CONSERVATION COMMISSION DETAILED AGENDA

Date: March 9, 2023

2. 68 Paradise Lane –NOI – Raze and rebuild of a lakefront home – DEP File #300-1155

- Representative has requested a continuation.
5. Staff Recommendations: Continue to next meeting as requested. Next meeting is March 30th.
6. **Lot 3, 20 Fiske Hill Road & 30 Main Street (Future Road named Berry Farm) – NOI-Construction of a 68 lot manufactured housing community-DEP File# 300-xxxx**

Attachment 1

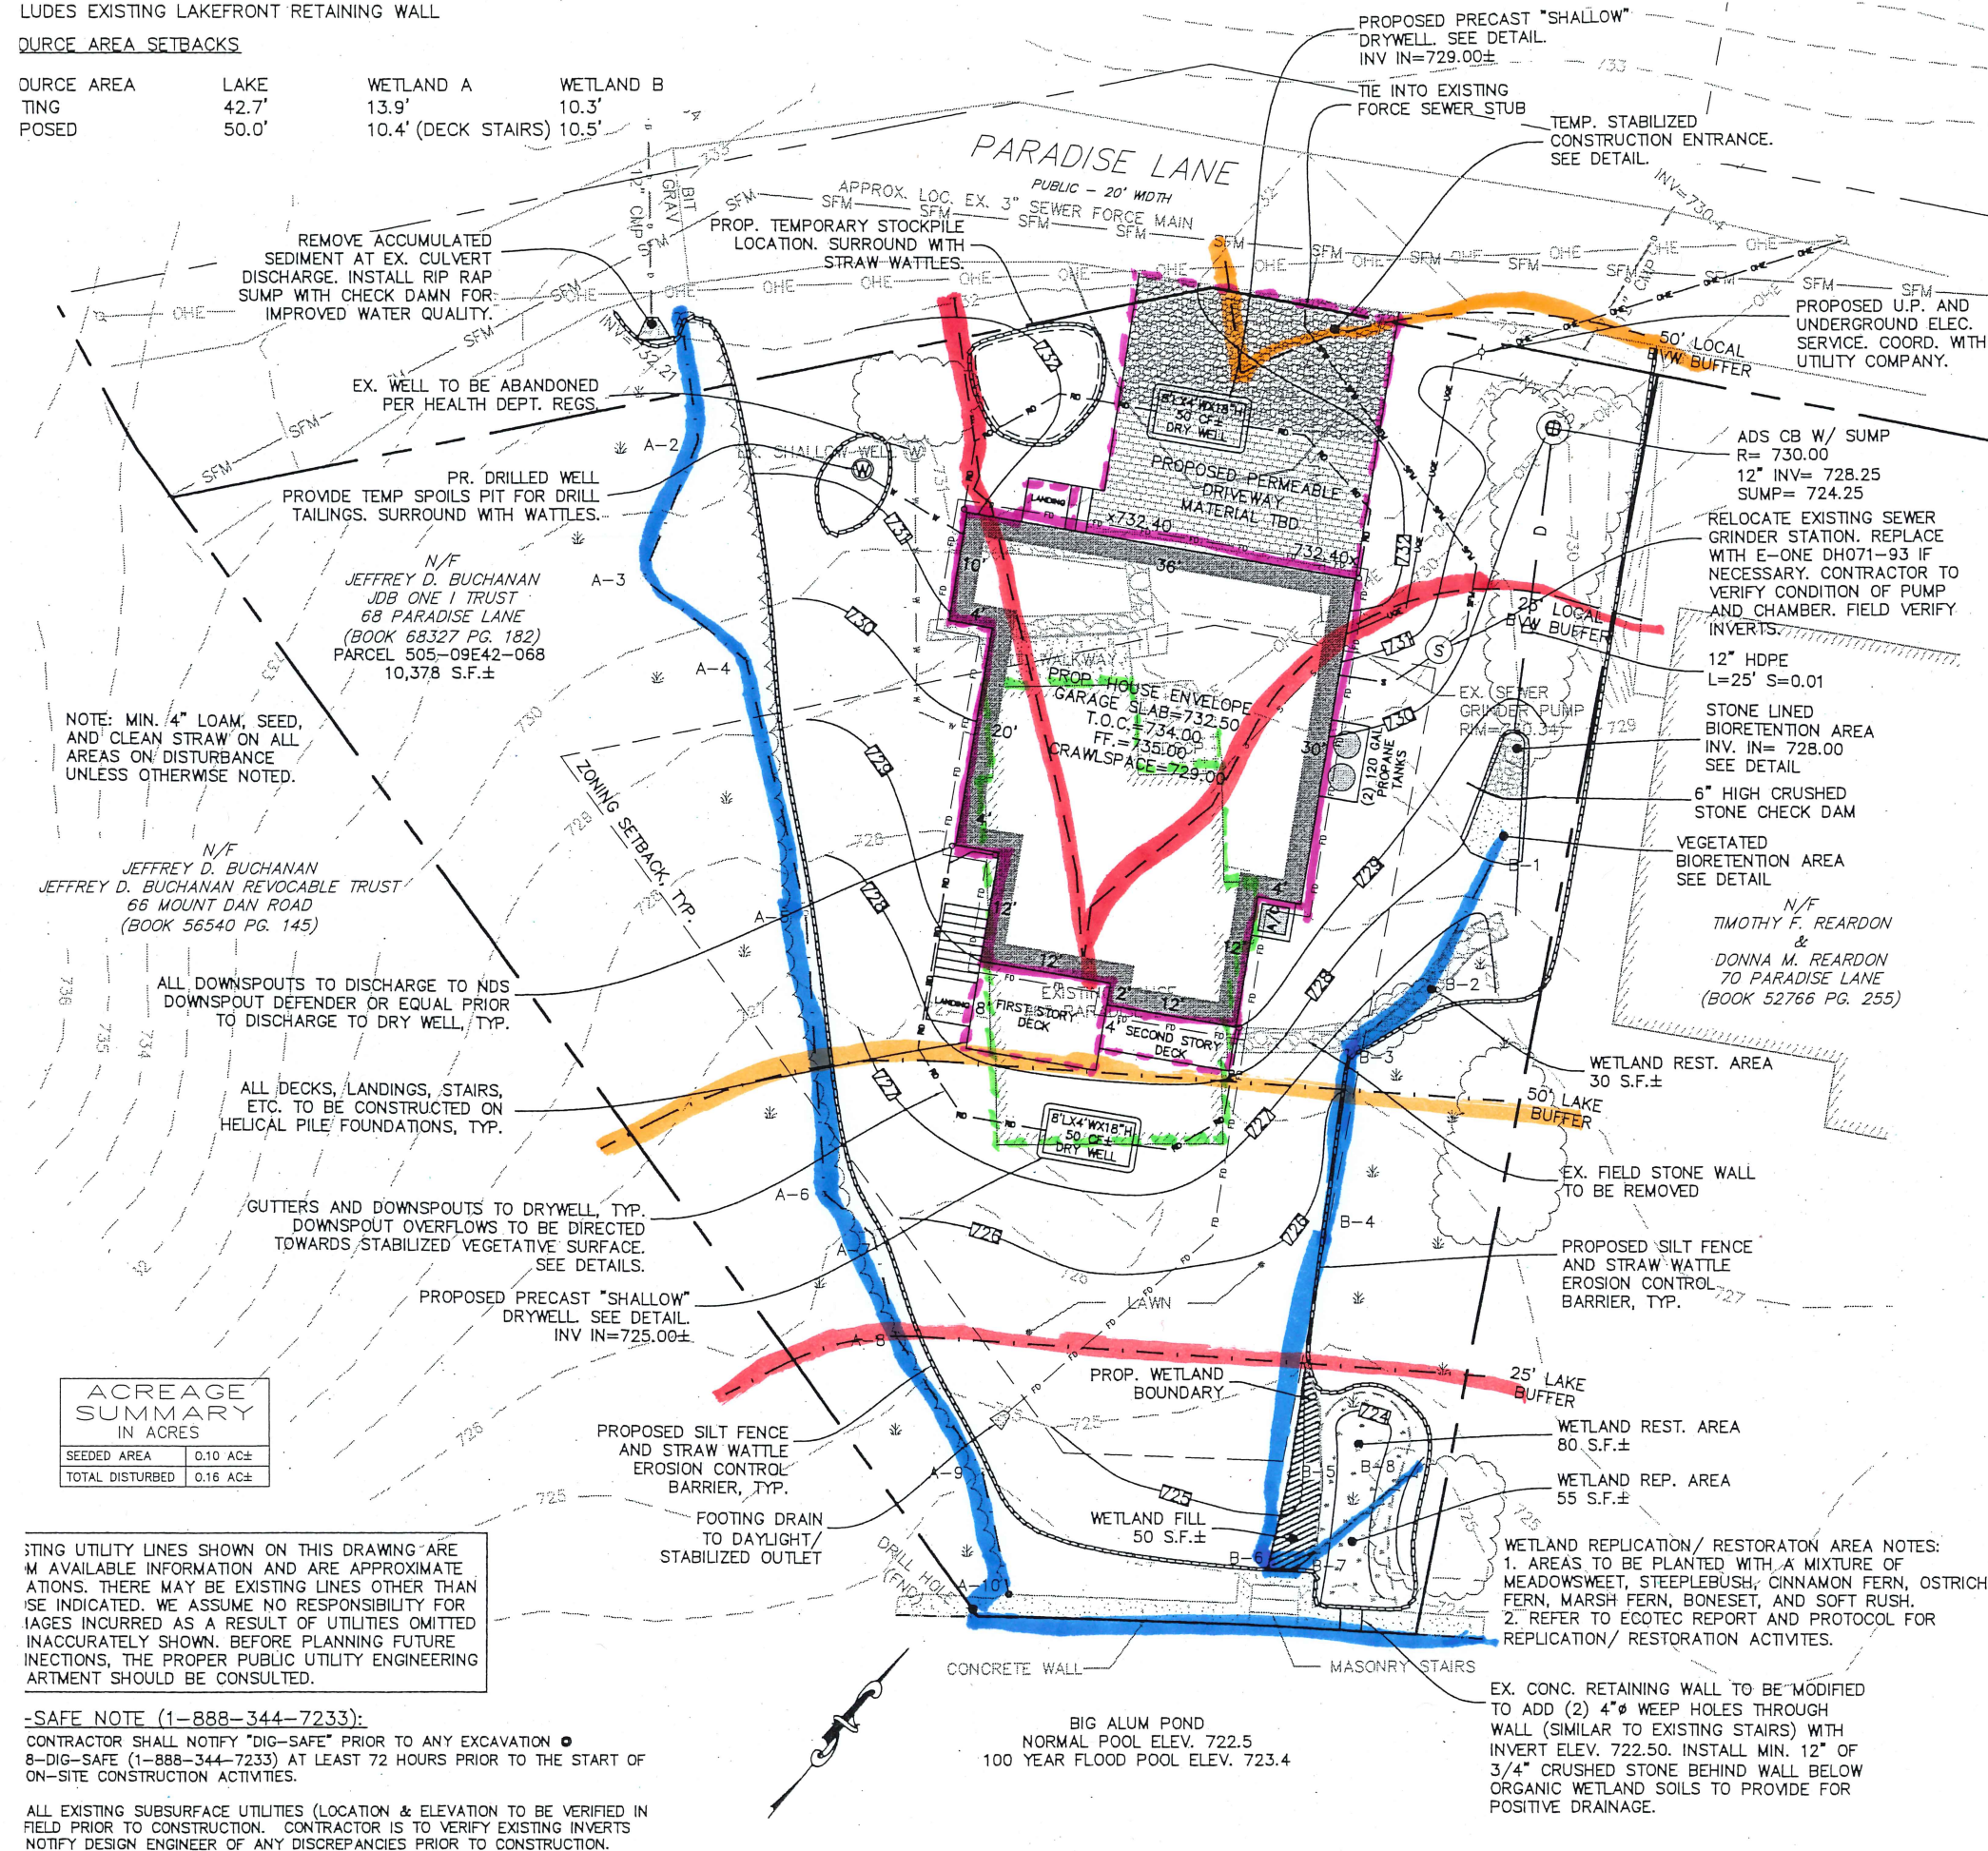
- 50 feet of BVW impacted noted in NOI. 55 feet noted on plan. Engineer to verify. Bank impact proposed for addition of pipes to allow weeping. Bank impact to be articulated and added. The addition of pipes to drain the area may impact the areas ability to function as a wetland and it should be reviewed if this will benefit the wetland or be detrimental.

- BLSF noted at elevation 723.4. Appears to slightly fall on the property 724 shown on the property however small amount of work may be within the BLSF for the replication. Engineer should verify if any work is within BLSF.

- New structure is within the 25' no disturb and 50' no build setback. Structure has been moved out of the 50' no build associated with the lake, which is an improvement, but does increase in footprint within 25' of the BVWs.

- Wetland encompasses part of lawn area that is over the shoreline stairs. Stair repairs recently made. Weeping pipes installed. Pipes had previously been located here and failure of pipes may have assisted with wetland expansion in the area.

- Project team is proposing to regrade area to direct runoff away from the stairs and fill portion of wetland at stairs. Proposing 55 sq feet of impact and replication of 105.

- Improvements proposed to stormwater here to include providing a deep sump catch basin for road runoff treatment and a vegetated bioretention area. These will be beneficial but could be improved by expanding retention areas. The ~50 ft drain pipe could be reduced to provide for a larger retention area.

- Additional improvements made within the wetland on the western side to remove accumulated sediment at culvert outlet. Is this on the subject parcel? Corrective grading proposed here also.

- Project includes dry wells for roof runoff infiltration. Do these areas support these structures? Depth to groundwater concerns?
 - Staff have been to this site w/ previous owners on various occasions. They had many concerns with saturation throughout most of the site. Site was saturated on various occasions that staff visited.

- Engineer should provide information on depth to groundwater to verify that a partial foundation can be installed here & BMPs. Project team should describe what would be required during construction and long term if high groundwater is encountered.

- Staff recommend that helical pilings be looked at to minimize disturbance and to eliminate these concerns. Staff are aware that a partial basement is preferred but this is a challenging site. Utilities could be located in the proposed garage.

- Footing drain shown to discharge just outside of the wetland.
 - Alternative analysis should be provided demonstrating no alternatives to the proposal per bylaw regs. Can a narrower structure be provided or reduced parking to decrease impervious or partially impervious surfaces? Could the proposed 2-car garage be minimized to expand living space and keep from expanding closer to the BVWs? Parking appears to have been significantly increased. New structure is moved away from the lake but encroaches on wetlands.

- A waiver would be required. Mitigation provided on revised plan. All options to meet the SWB standards must be explored and documented in able to be eligible for a waiver.

- A breakdown of the existing structure and new structure within 25' and 50' of resource areas is shown on the plan. This also includes impervious areas. What are the impervious areas used for the calculations? How much increase in parking areas (shown as permeable driveway) is proposed? Include in table.

- Will need an O & M Plan for all stormwater BMPs and pervious structures.
 - The board may want to consider a vegetated buffer along the BVW lines to create a no disturb buffer and want to consider concrete bounds or other markers clearly identifying the wetlands or that no disturb buffer as outlined in SWB Regs 365-1.1 which states: "At the discretion of the Commission, concrete bounds or other appropriate permanent markers clearly delineating the twenty-five-foot "no disturb" buffer, or any alternative approved-width "no disturb" buffer the Commission imposes for each property, are to be installed prior to the start of any work on-site."

SPECIAL PERMIT AND SITE PLAN
 "BLUEBERRY HILL ESTATES"
 LOT 3 BERRY FARMS ROAD
 STURBRIDGE, MA 01566
 PREPARED FOR
 JUSTIN STELLMOK
 557 SOUTHWEST CUTOFF
 WORCESTER, MA 01607

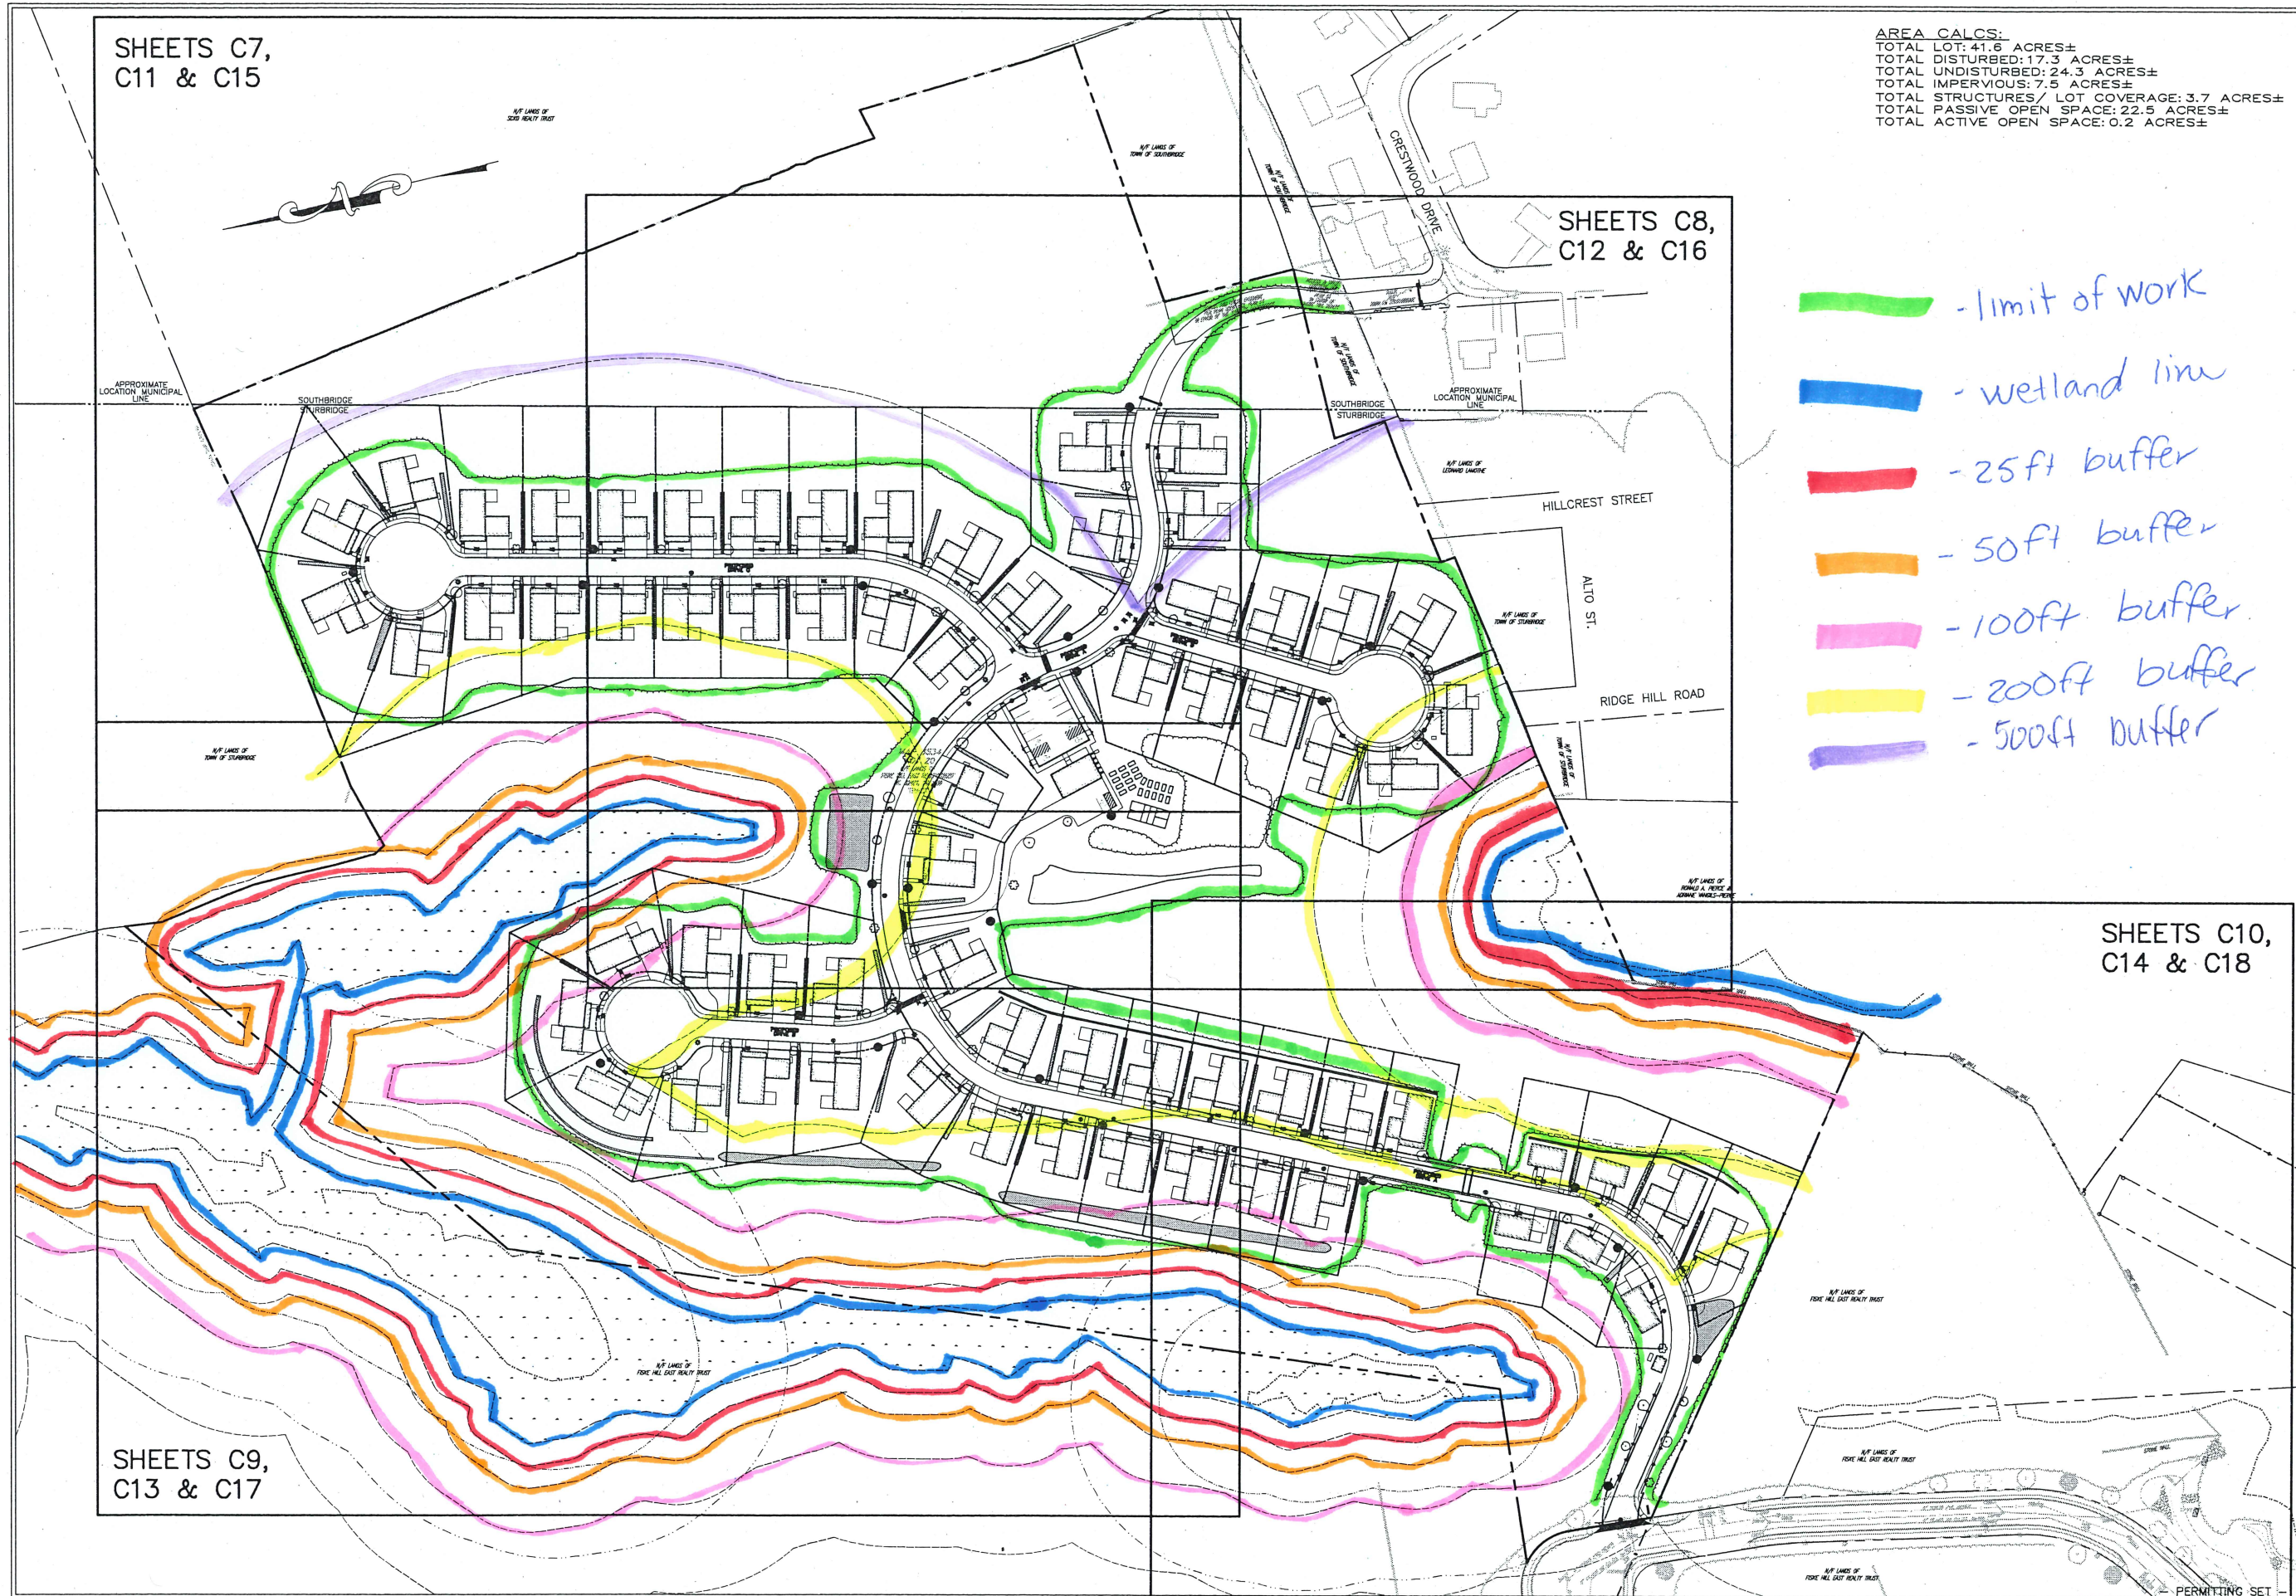
- See Attachment 2 of this agenda, for a colored plan which outlines the overall limit of work for the project and the applicable state and local buffer zones. Work is primarily located outside of the 50 foot no new structure setback but it does approach the 25 foot no disturb setback in one location.
